In accordance with 36 CFR §218, Bark and NEST hereby object to the Environmental Assessment (“EA”) and draft Decision Notice for the North Clack Timber Sale.

Responsible Official: Richard Periman, Forest Supervisor, Mt. Hood National Forest

Location: North Fork Clackamas Watershed, Clackamas River Ranger District, Mt. Hood National Forest

Fig. 1: Objectors' proposed remedy for units 4 & 6

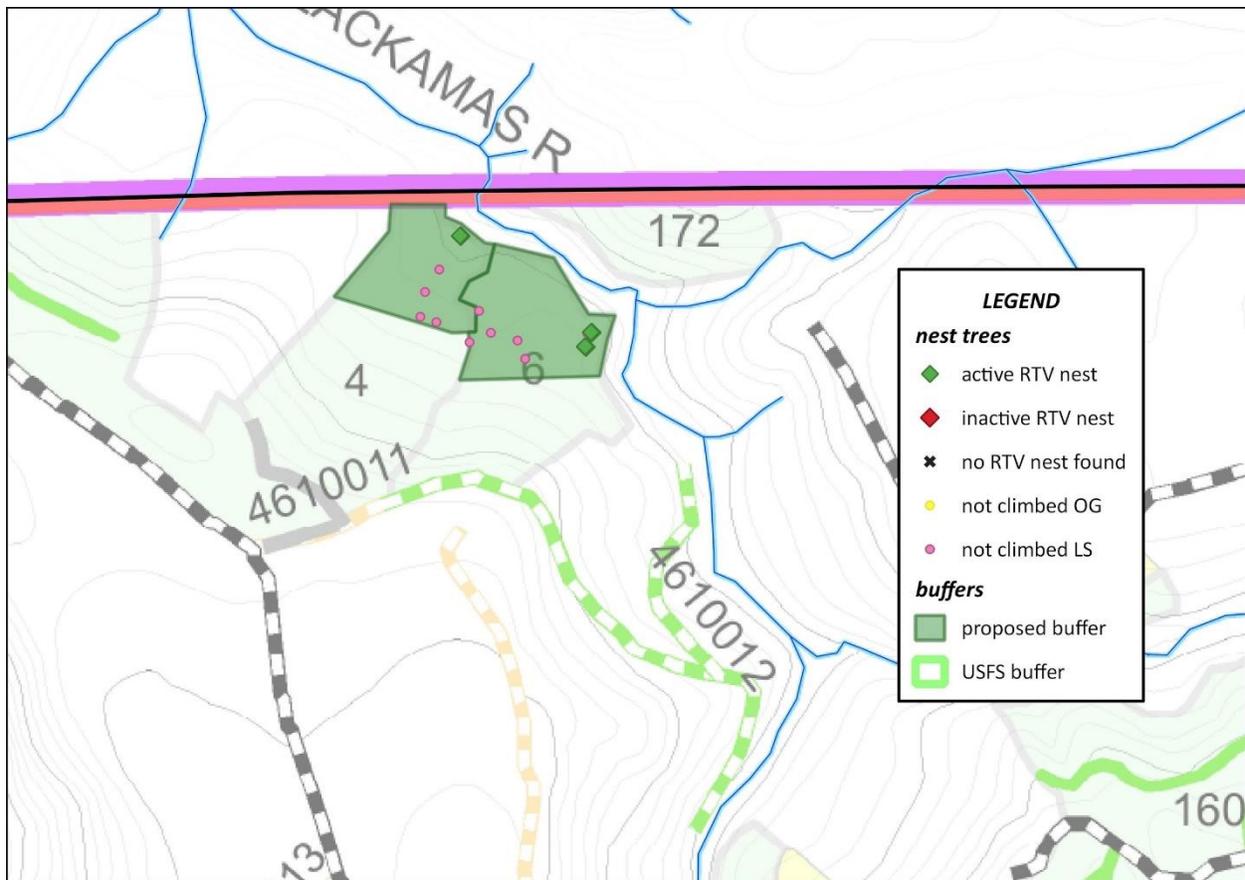
On 8/9/19, NEST shared with the FS locations of 2 active nests in Unit 6 and 1 active nest in Unit 4. These nests did not receive Management Areas in the North Clack Draft Decision. In addition to these active nests, Bark has also located 9 late seral trees (shown below) within general proximity of the known nests (within 100 meters) in these two units.

To ensure that the best habitat is protected through the creation of Management Areas, two proposed 10-acre buffers (one centered on the active nest in Unit 4, and one centered on the two active nests in Unit 6 as shown below) should be created which include the late seral trees which will act as suitable trees for dispersal of the existing population of this species.

Fig 2: Objectors' proposed remedy for unit 18

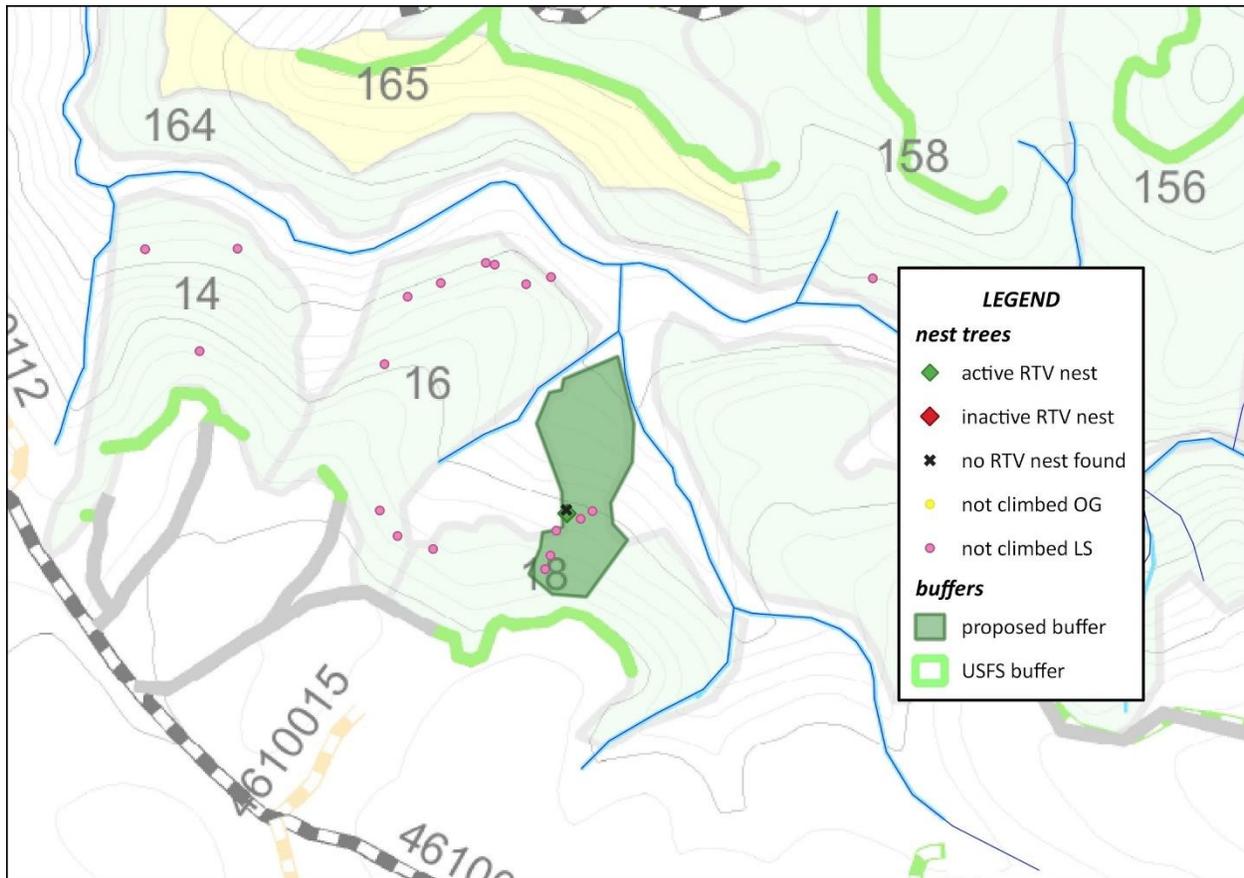
On 6/10/19, NEST shared with the FS the location of 1 active nest in Unit 18. This nest did not receive a Management Area in the North Clack Draft Decision. NEST only had a chance to fully climb one tree in Unit 18 and located an active nest. This indicates an extremely high likelihood of additional active nests in the area and a strong rationale for placing a Management Area around the *known* active nest.

Given that that several more suitable trees exist in this unit, we ask that a 10-acre buffer be placed over the known active nest (shown below) so that the surrounding habitat and likely additional nests are protected.

Fig. 3: Objectors' proposed remedy for units 92 & 94

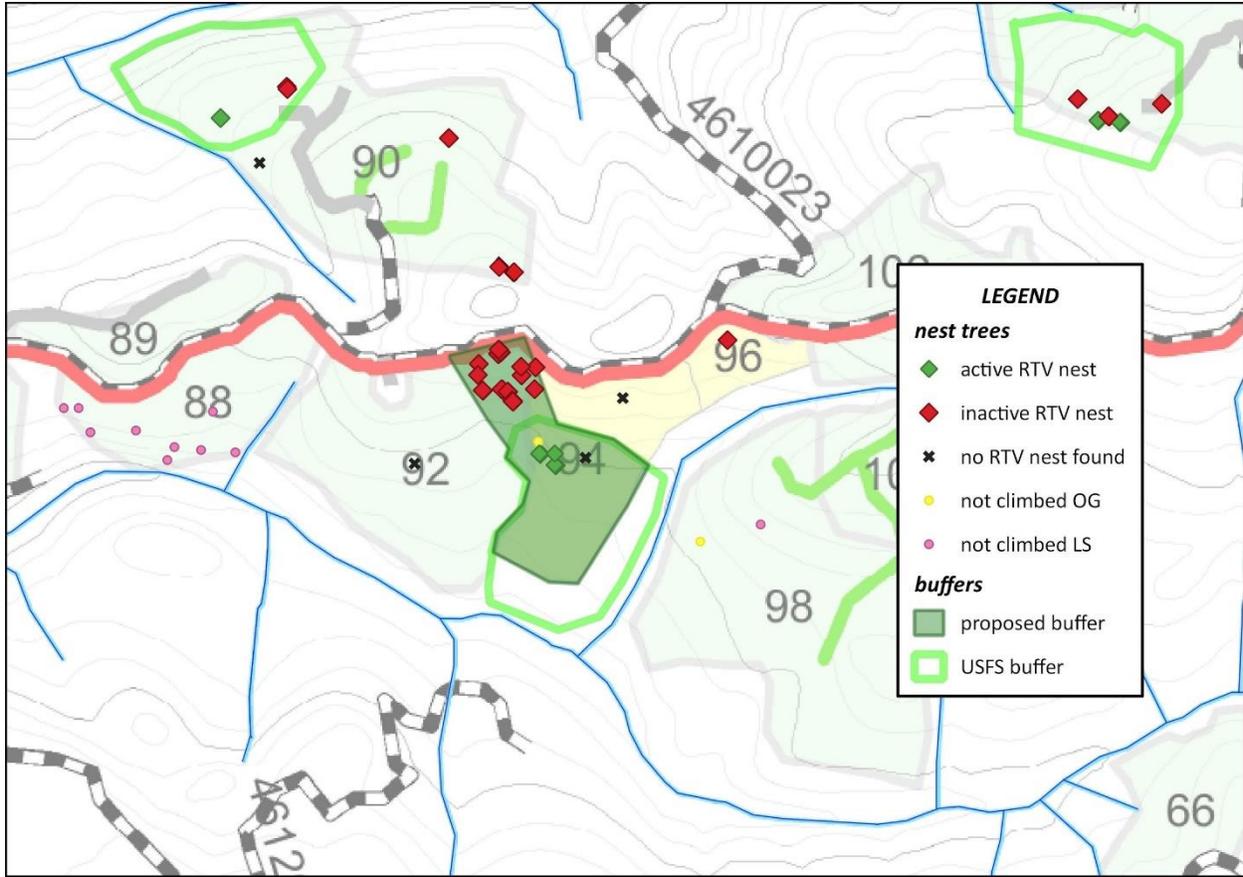
On 7/18/19 and 8/9/19, NEST shared locations of 10 inactive nests in Unit 92, as well as 3 active and 1 inactive nest in Unit 94. Since these nests in addition to nearby ones located by FS-contracted climbers are clustered to an area where the most distant trees including active nests do not surpass being 100 meters apart, a modified Management Area is required that includes the inactive nest trees in Unit 94.

In addition to meeting this clustered nest requirement, changing the buffer to include the inactive nests in Unit 94 also protects the best habitat - since red tree voles clearly have been very active in this part of the stand before. The Red Tree Vole Management Recommendations states that “(i)f the habitat containing the inactive site is currently suitable for red tree voles, or is anticipated to achieve the desired condition through natural processes, then no treatment would be needed.” The draw that extends down between unit 92 and 94 is high quality late seral habitat which will provide additional habitat connectivity for the species in this area.

Fig 4: Objectors' proposed remedy for unit 106

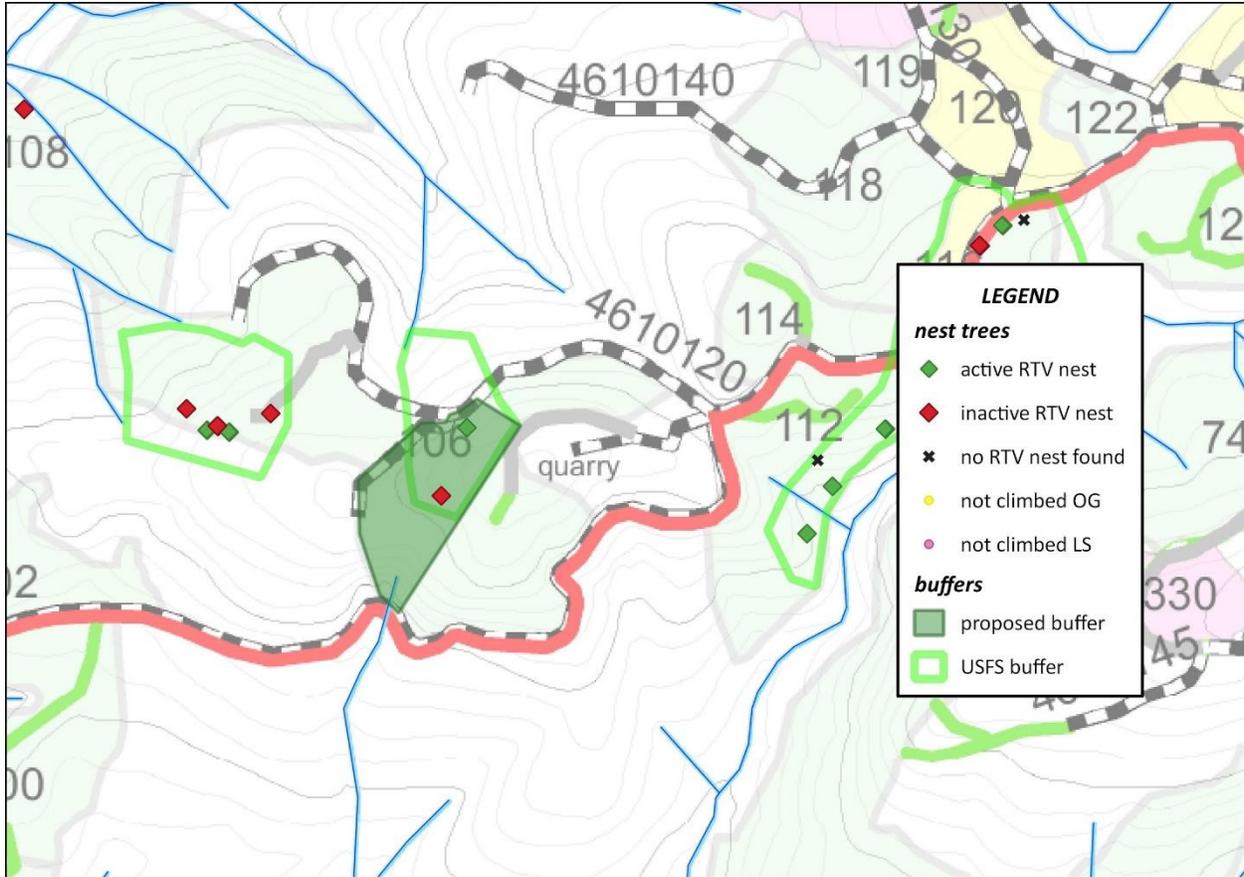
On 10/17/18, NEST shared with the FS the location of 1 active and 1 inactive nest in Unit 106. In the Draft Decision, approximately half of the Management Area drawn for this unit includes a stand which is separated from the area containing the nests by FSR 4610-120 and a connected spur. To provide the best habitat connectivity for the species, the FS should adjust the buffer area to include a larger section south within Unit 106 that would not require a red tree vole to cross two roads to disperse to.

Fig. 5: Objectors' proposed remedy for unit 198

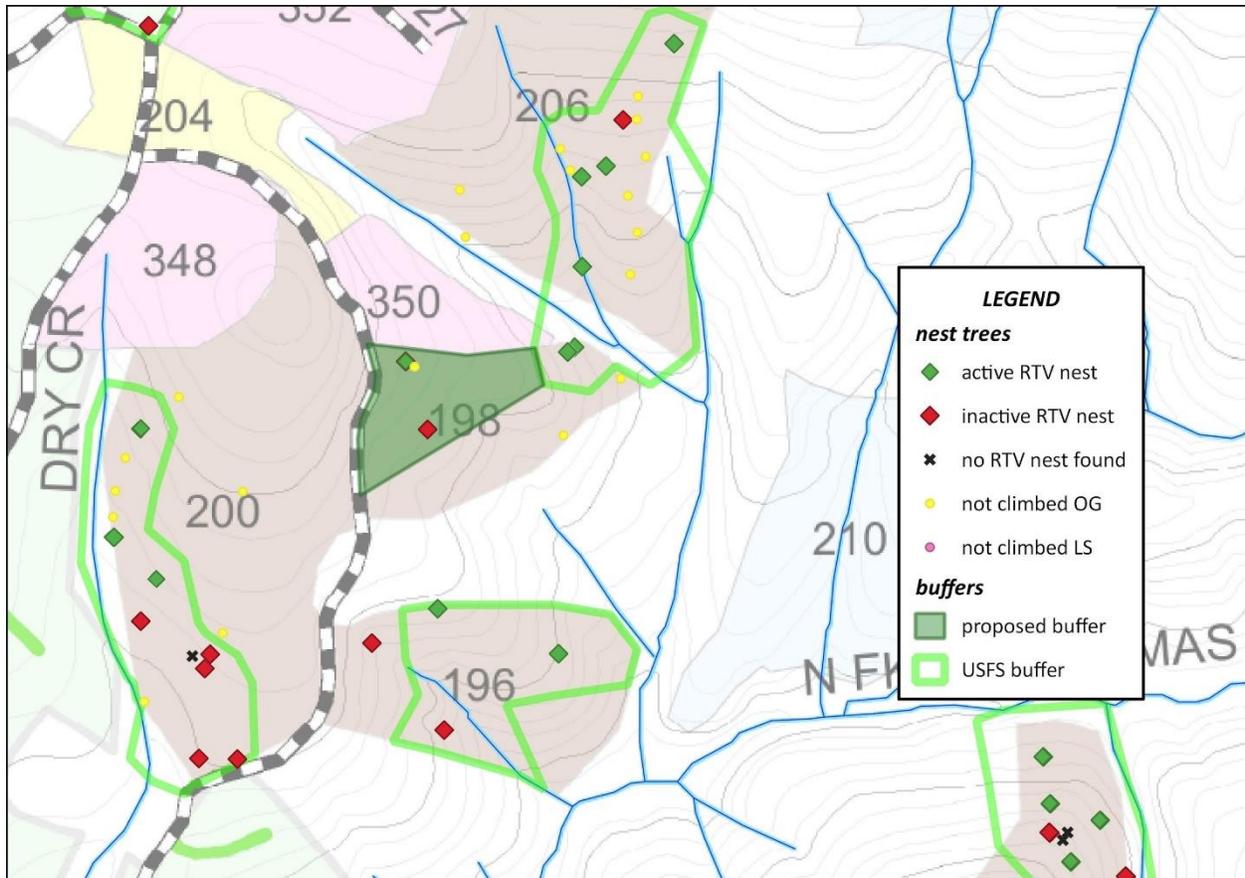
On 12/24/19, NEST shared with the FS the location of 1 active nest in Unit 198, near the boundary with Unit 350. The data submitted included a typo which indicated that the nest was inactive (INAC-MO), however evidence of an active nest included fresh cuttings, scat and resin ducts - all of which were included on NEST's data submitted for this unit. Present at the tree during the climb was a reporter from the Oregonian (Kale Williams), as well as Bark staff who witnessed these samples being taken. To protect this active nest, the FS should delineate a 10-acre Management Area as shown below - which provides additional connectivity to the one already delineated in the eastern part of the unit.

Fig. 6: “Gap” in Shell unit 60

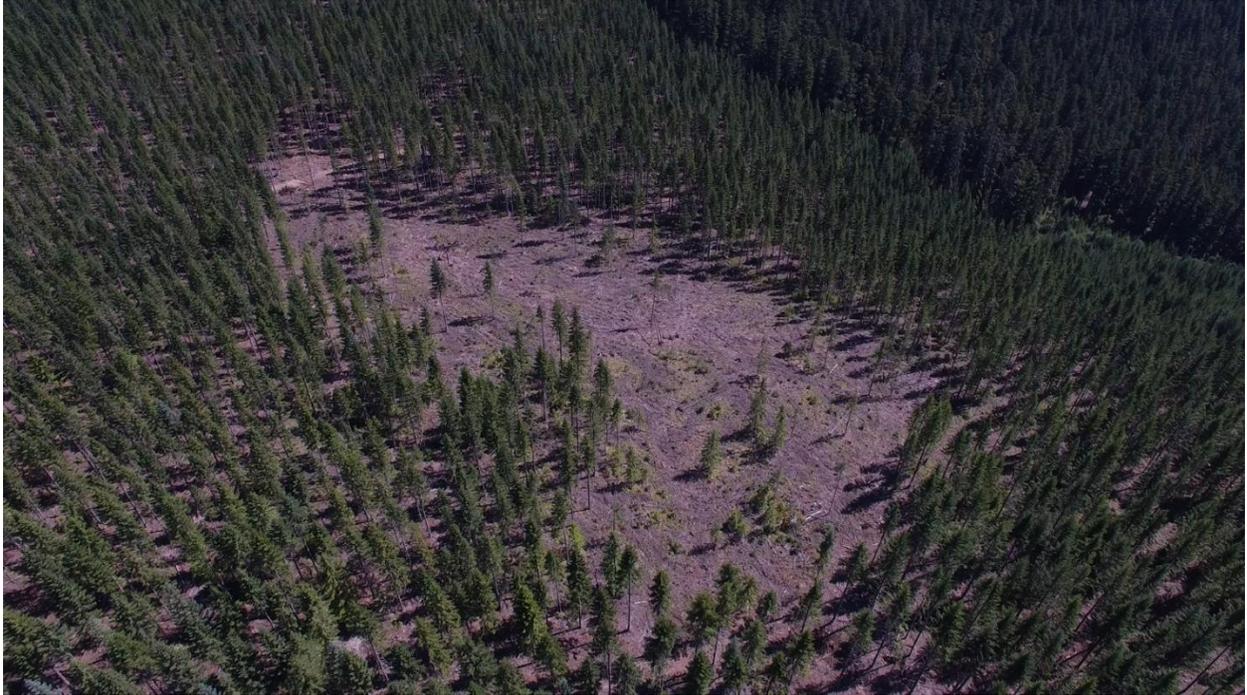
Officer to view these photos and ask the planners of the North Clack project what “high quality” forage would grow in a 30 acre clearcut that would not grow in the gaps shown below.
